V2500-A1/A5/D5 SERIES PROPULSION SYSTEMS NON-MODIFICATION SERVICE BULLETIN

This document transmits Revision 2 to Alert Non-Modification Service Bulletin V2500-ENG-72-A0510

ENGINE – HIGH PRESSURE (HP) COMPRESSOR – VORTEX REDUCER INSPECTION AND OVERHAUL
POLICY – ALERT NON-MODIFICATION SERVICE BULLETIN

Flow Chart for engines - In Service
Figure 1

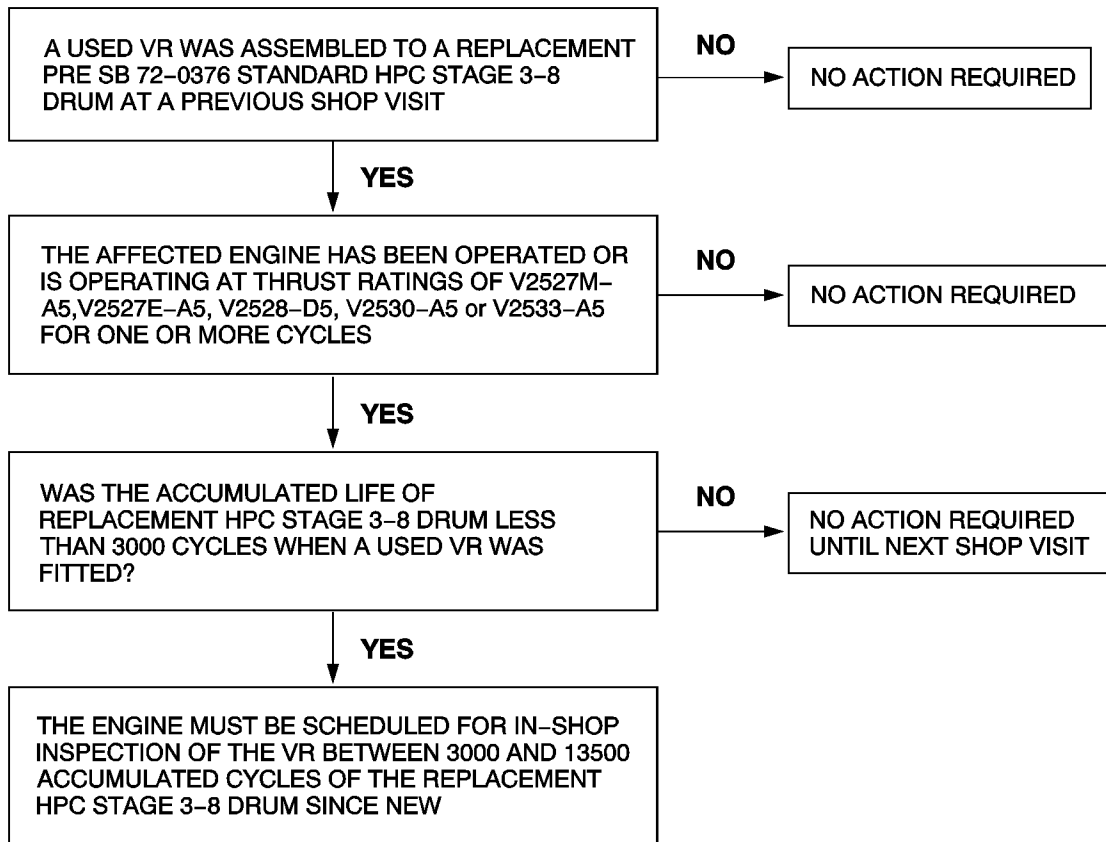
the vortex reducer must be inspected between 3000 and 13500 accumulated cycles
of the replacement HP compressor stage 3 to 8 drum of pre Service Bulletin
V2500-ENG-72-0376 standard. (Refer to Figure 1 and 2)

NOTE: If the affected HP compressor stage 3 to 8 drum has already accumulated
R more than 13500 cycles since new and the inspection, in accordance with
this Alert Non-Modification Service Bulletin, has not not been carried
out, then the engine is to be scheduled for immediate vortex reducer
inspection.

NOTE: The vortex reducer inspection must be repeated between 3000 and 13500
accumulated cycles of the HP compressor stage 3 to 8 drum, if the vortex
reducer was inspected and re-assembled before the replacement HP
compressor stage 3 to 8 drum of pre Service Bulletin V2500-ENG-72-0376
standard had accumulated a drum life above 3000 cycles.

Flow Chart for engines - At Overhaul
Figure 2

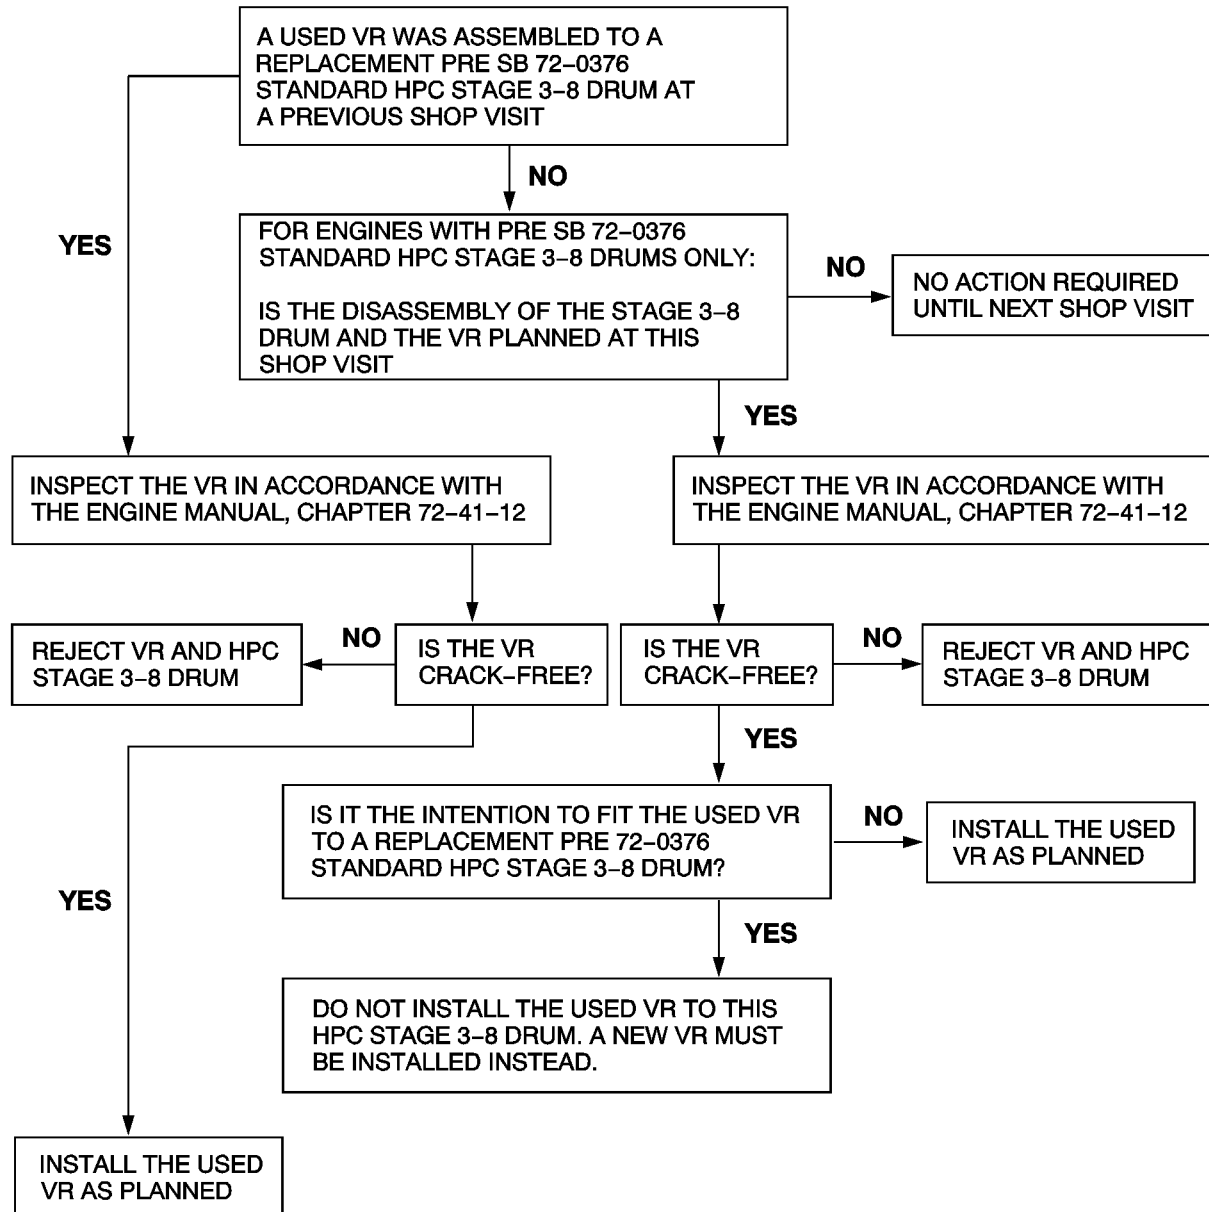
NOTE: When a replacement HP compressor stage 3 to 8 drum of pre Service
Bulletin V2500-ENG-72-0376 standard is to be installed in an affected
engine in the shop, then a new vortex reducer must be fitted.

R NOTE: No inspection is required at this shop visit if the used vortex reducer
has not been installed to a replacement HP compressor stage 3 to 8 drum
R of pre Service Bulletin V2500-ENG-72-0376 standard at a previous shop
visit.
